Informal Document No. GRSP-39-9/Rev.1

Japan's Feasibility Study of
ECE/TRANS/WP.29/GRSP/2005/5/Rev.1
UNECE-Regulation No.16

Requirements for Acceleration Sleds [R.16 GRSP/2005/5/Rev.1]

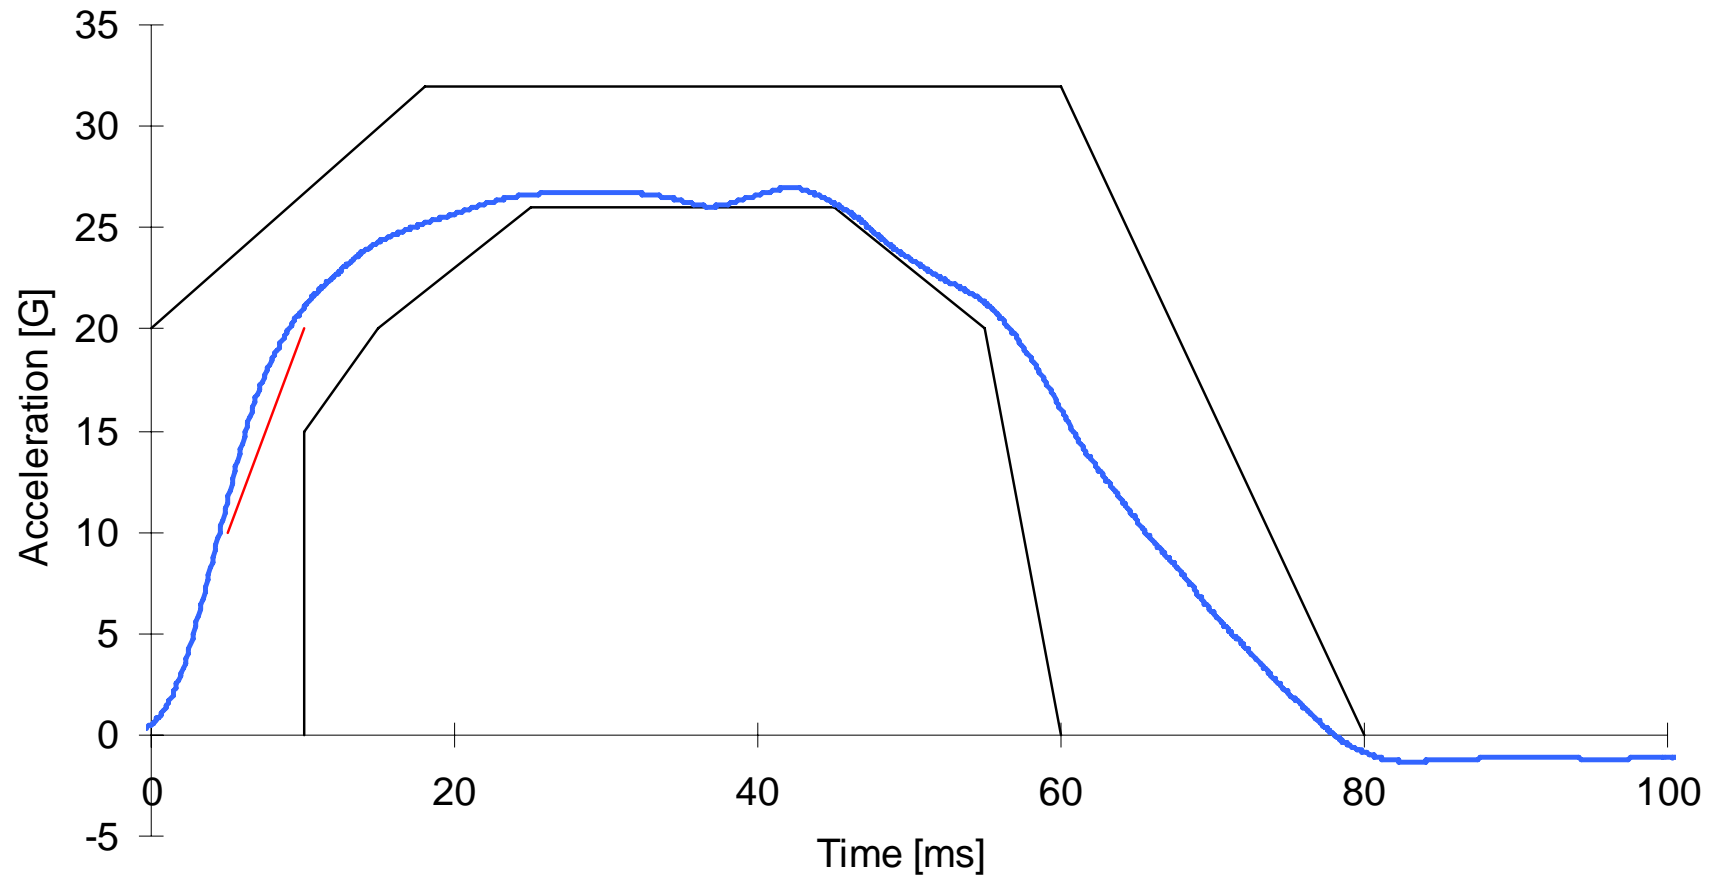
A: Acceleration curve within the corridor

B: $\Delta V = 51 \pm 2/0$ (km/h)

C: Initial slope of acceleration
5ms-10G & 10ms-20G

~~D: Acceleration distance
50 \pm 1/0km/h = 40 \pm 5 (cm)~~

The acceleration device (HYGE) met all requirements by improving the metering-pin.

The verification test result shows that the requirements specified in GRSP/2005/5/Rev.1 can be satisfied under **the calibration condition** (without a dummy/safety belt).

To specify this requirement for only **calibration condition**, we would like to propose to amend GRSP/2005/Rev.1 as same as “Deceleration test device”.
